### Addendum 122 – UN Regulation No. 123

Revision 2 – Amendment 4

Supplement 8 to the 01 series of amendments – Date of entry into force: 10 October 2017

# Uniform provisions concerning the approval of adaptive front-lighting systems (AFS) for motor vehicles

"Figure 1

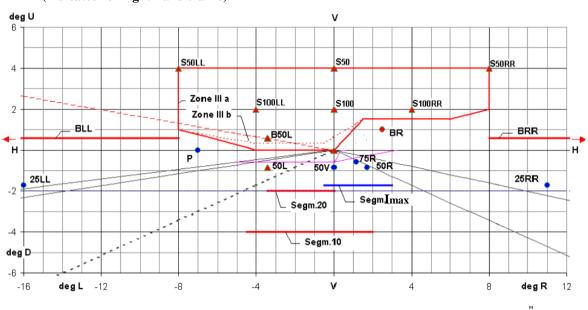
Figure 1, amend to read:

Angular positions of passing beam photometric requirements (indicated for right-hand traffic)
